# **CALIFORNIA COASTAL COMMISSION**

# STAFF REPORT: CONSENT CALENDAR

**APPLICATION NUMBER: 5-08-008**

PROJECT LOCATION: 74 N. La Senda, City of Laguna Beach (Orange County)

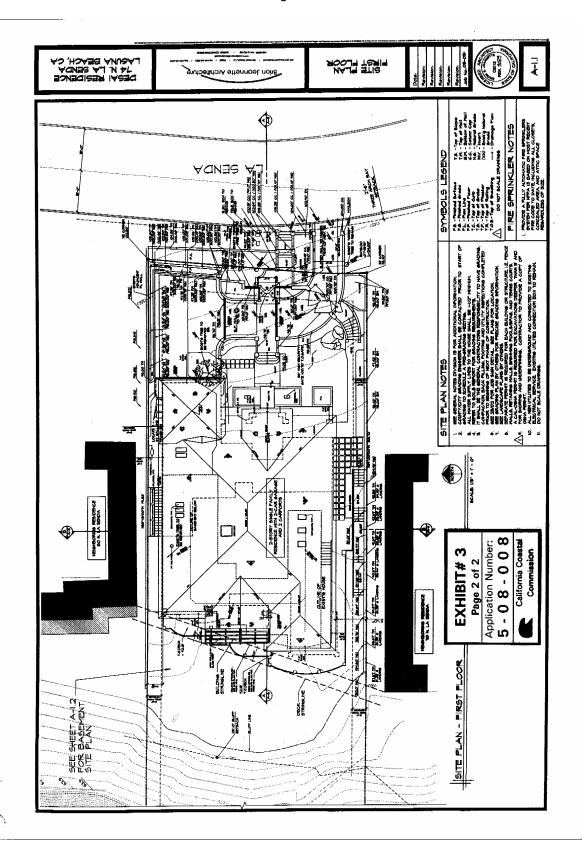
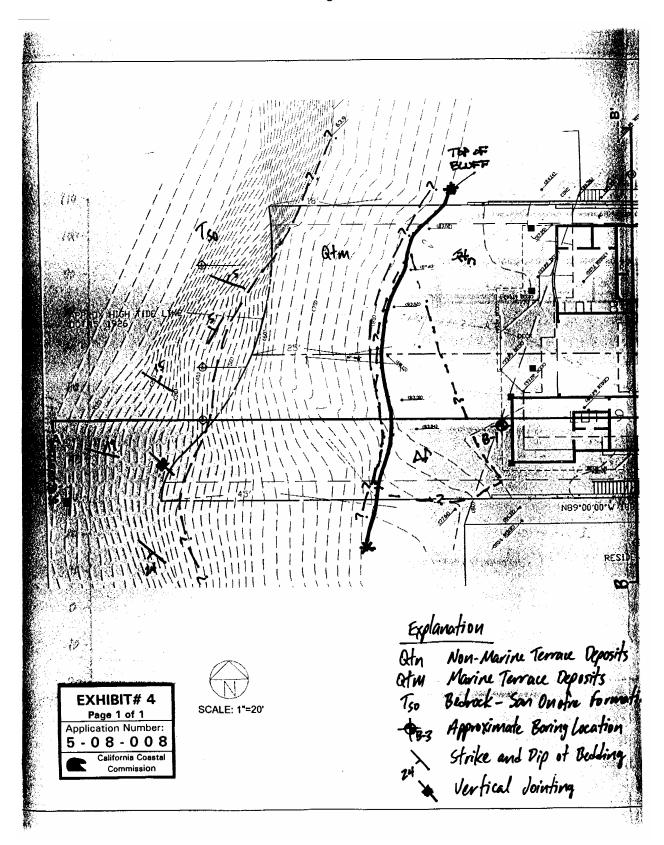
That the proposed residence shall be, at minimum, setback 25-feet from the bluff edge (consistent with plans submitted by the applicant on January 9, 2008) and any existing hardscape and appurtenances and any proposed hardscape and

appurtenances and any grading be setback, at minimum, 5 feet from the bluff edge as generally depicted on Exhibit #4 of the this staff report dated March 18, 2008. The bluff edge presently follows the 83-foot elevation contour as generally depicted on Exhibit #4 of the staff report dated March 18, 2008.

The applicant's geologic consultant has determined that the edge of the bluff on this site is generally located along the 83 foot contour elevation (see Exhibit #4). Commission staff has reviewed the applicant's bluff edge determination and concurs. The bluff edge determination is based on the definition contained in Section 13577 of the California Code of Regulations which states, in part: "the edge shall be defined as that point nearest the cliff beyond which the downward gradient of the land surface increases more or less continuously until it reaches the general gradient of the cliff."

In the case of the subject site and proposed development, application of a stringline results in a more restrictive setback than the 25-foot setback (see Exhibit #4). By incorporating the stringline setback with the proposed development, both the lower and upper level living areas of the proposed single-family residence also comply with the 25-foot set back from the bluff edge (see Exhibit #3). In order to protect scenic coastal views and provide equity among bluff top development in the project area, the Commission finds that a stringline setback is appropriate for the proposed development.
